**Town of Atherton
Planning Department
80 Fair Oaks Lane
Atherton, California 94027
Phone: (650) 752-0544**

DATE: OCTOBER 23, 2024

FROM: SEAN MANALO, CONSULTING ASSOCIATE PLANNER

SUBJECT: Request for Tree Protection Zone Exception (PTPZ24-00007) for a driveway and detached garage at 64 Winchester Drive (APN 070-230-060).

**Figure 3: Project Configuration and Layout, Proposed Location, Enlarged
(Attachment 2, Sheet A1.0)**

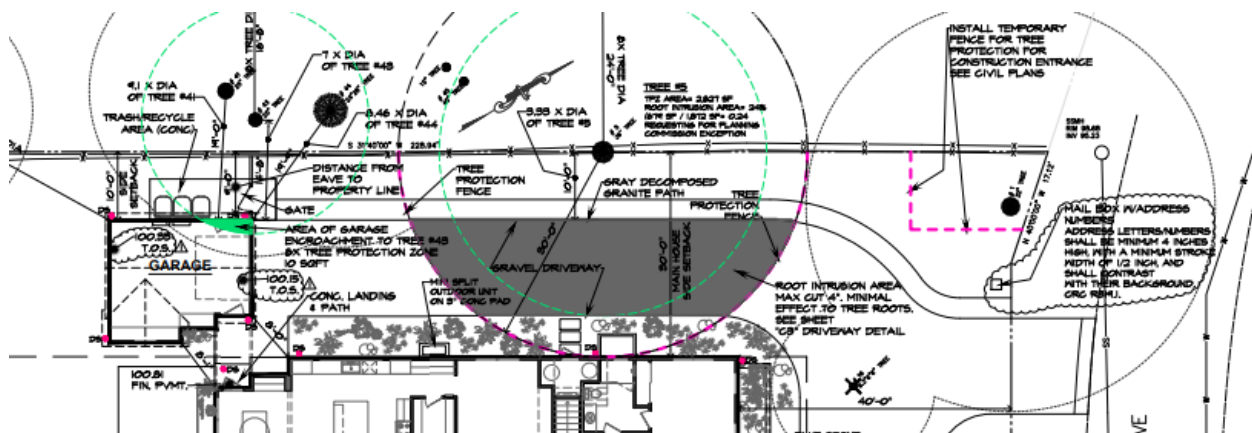
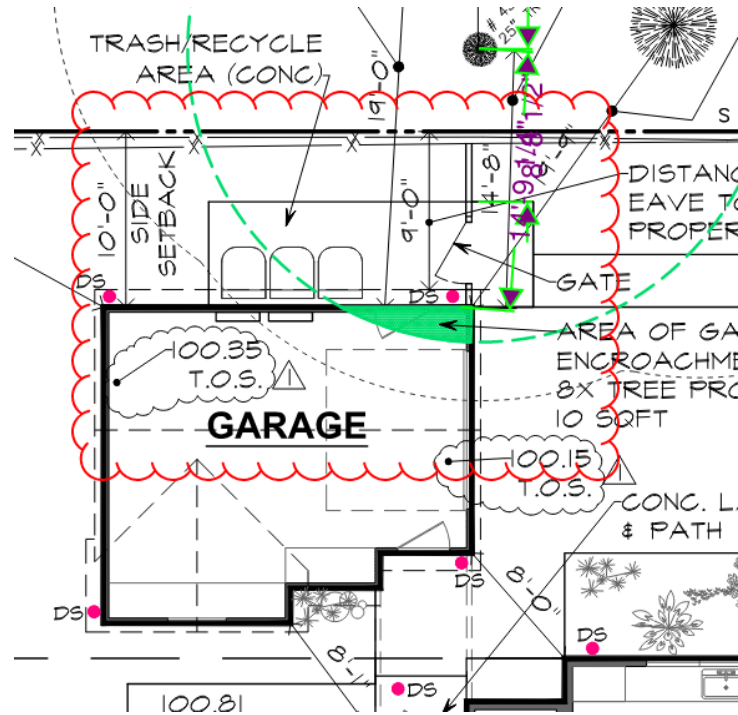
The Applicant did not provide alternative locations for the proposed garage and driveway. The applicant's narrative indicates however that the proposed location is ideal for the property owners to enjoy reasonable access to the lot (Attachment 4). The applicant's narrative also includes a neighbor letter from the adjacent property at 60 Winchester Drive where the subject trees are located. The neighbor at 60 Winchester Drive expresses support for the proposed project.

A memo by the Town Arborist analyzing the proposed project is provided in (Attachment 5). In this memo, the Town Arborist indicates that Redwoods are rated as having a good tolerance of construction impacts. The Town Arborist indicated that no other locations were explored for the garage and driveway and a report on exploratory trenching was not included. Additionally, the Town Arborist recognized that any roots 2-inches and greater can be protected and that the driveway uses Biaxial geogrid with only 4-inches of rough grading and less than 26.5% of roots will be affected. In this way, the Town Arborist recommended approval of the two requests and asserts a recommendation to approve the request for construction of the driveway and detached garage with the following requirements:

- Biaxial Geogrid (Tensar BX-1100) as an underlayment to be placed on top of the parent soil. Minor rough surface grading not to exceed more than 4". Biaxial Geogrid (Tensar

BX-1100 or equivalent) to be placed on the soil with only hand-tampered compaction preparation used. Edging needed is recommended to be supported above ground by individual stakes. Adherence to these requirements shall be reflected on G&D plans.

- Any work 10x of the neighbor's trees, driveway and pathway built with hand work only. Project arborist to be on site.
- The area between the Redwood Tree #43 and the foundation (tree protection zone) is required to be irrigated every other week during the dry season until the top foot of the soil is saturated. This tree is also to be deep water fertilized with Nutri Root. Adherence to these requirements shall be reflected on quarterly report.

- The entire proposed foundation, when within 10x the diameter of Redwood Tree #43 tree (20.8'), is recommended/required to be excavated by hand in combination with hand tools such as an air knife, rotary hammer with clay spade attachment, or shovels, while under the direct supervision of the Project Arborist. All roots encountered within the foundation area measuring 1.5" in diameter or larger are recommended to be retained for the Project Arborist to inspect before being cleanly cut. Once inspected and documented, the roots will need to be cleanly cut using a hand saw or loppers. It is recommended that the cut root ends on the tree side be covered by 3 layers of wetted-down burlap to help avoid root desiccation. The contractor shall wet down the burlap daily while exposed. Adherence to these requirements shall be reflected on quarterly report.

- Deep water fertilizing the tree with Nutriroot should take place before the work has started and again the following spring. Adherence to these requirements shall be reflected on quarterly report.

- Exposed roots will be required to be documented by the Project Arborist. Before the driveway work is to start, the tree protection zone is recommended to be deep water fertilized with 300 gallons of water mixed with Nutriroot. The top foot of the soil within the tree protection zone is recommended to be saturated. A decomposed granite pathway is proposed to follow the edge of the driveway near oak tree #5. The pathway is recommended to be built with a minimal 4" cut into grade. This work will need to be done by hand under the project arborist supervision when working within 30' from the tree. No roots shall be cut for the pathway work. Any root encountered must be retained within the granite itself or base rock layer. Adherence to these requirements shall be reflected on G&D and quarterly report.

- Because the driveway work is to take place within the tree's tree protection zone, the work will require the direct supervision of the Project Arborist. Grading and scarifying the soil will need to be done by hand under the Project Arborist's supervision when working within 30 feet of tree #5. Any exposed roots during the driveway work will need to be kept moist by covering roots in layers of wetted-down burlap to help avoid root desiccation. Adherence to these requirements shall be reflected quarterly report.

- No roots over 2" to be cut per Town code.
- All excavation is to be done by hand under the Project Arborist supervision when within 10x the tree's diameter.

- Sufficient tree protection installed.
